STAFF REPORT

APPLICATION SEA 80-LV-061

APPLICANT: Furnace Associates, Inc.

PROPOSAL: Amend a previously-approved special exception for a landfill to permit an increase in the maximum height of the landfill from 290 feet above sea level to 412 feet above sea level and other site modifications, to increase the land area of the landfill from 249.36 acres to 250.15 acres and to permit a quasi-public park on the closed portions of the landfill (the park would ultimately become a public park)

SIGHT DISTANCE - PRIMARY TRUCK ENTRANCE

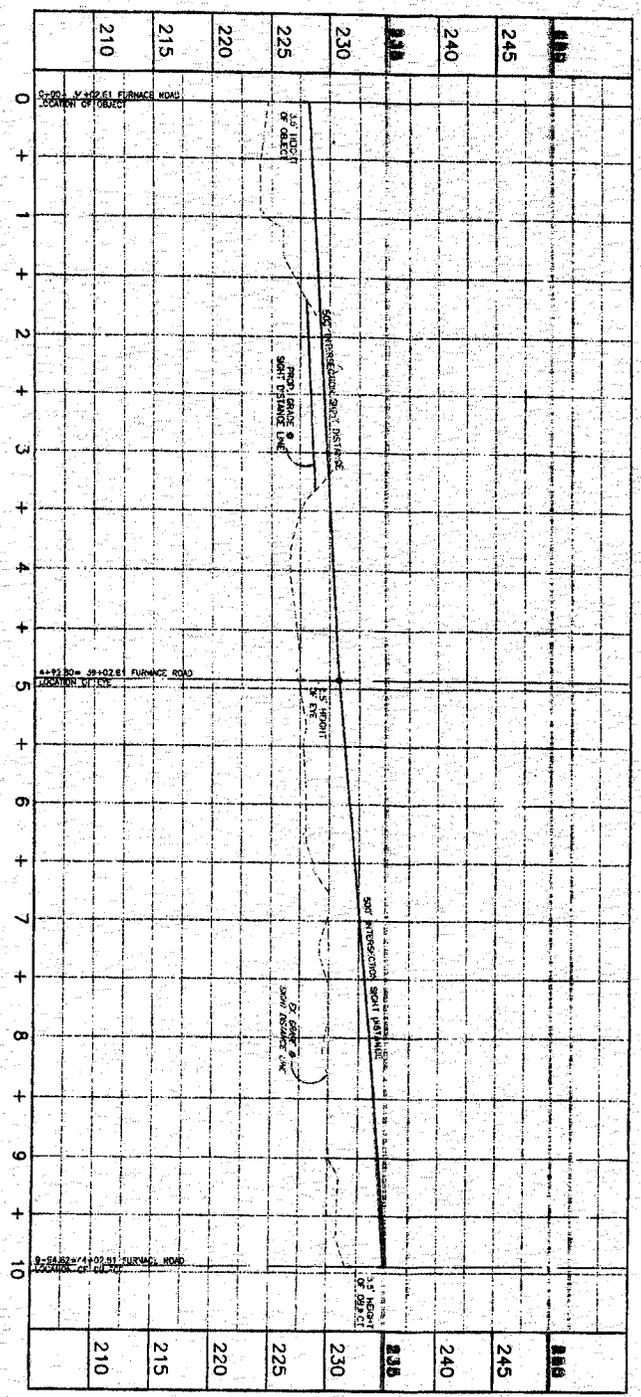
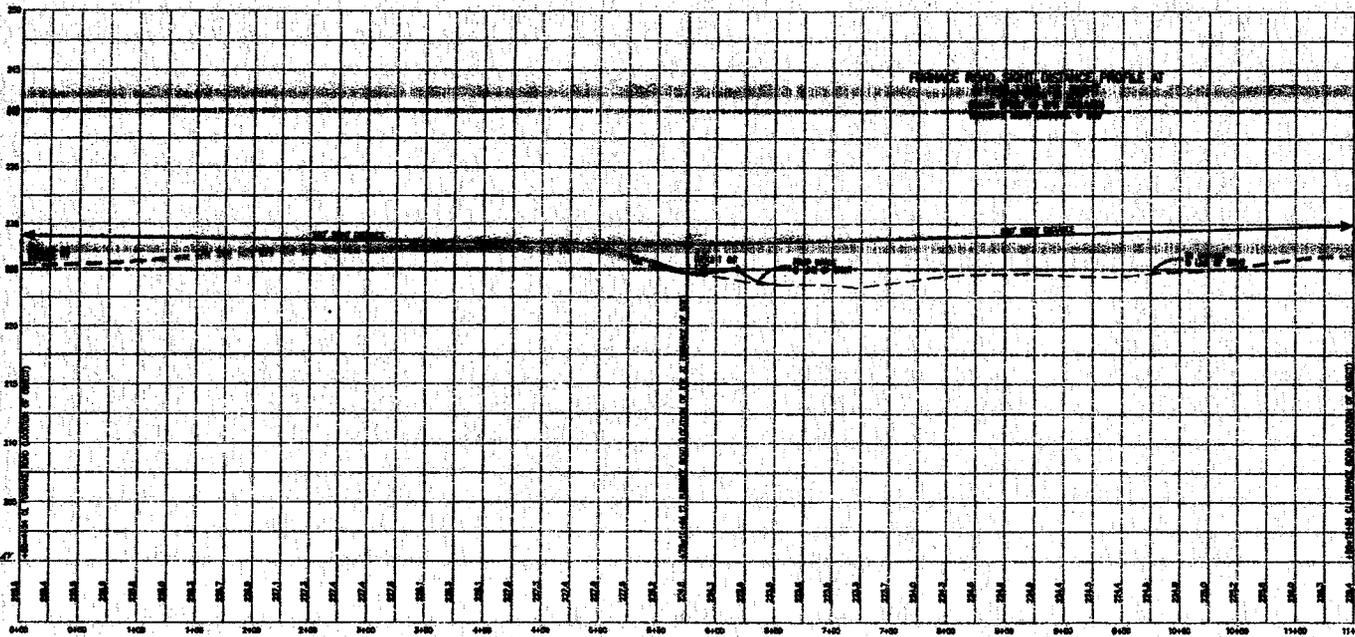
The applicant has noted that adequate sight distance can be provided with additional grading along the entrance (see Sheet 34 of the SEA Plat). Therefore, staff recommends a development condition that would require the applicant to provide these grading improvements at the main entrance in order to meet VDOT sight distance requirements.
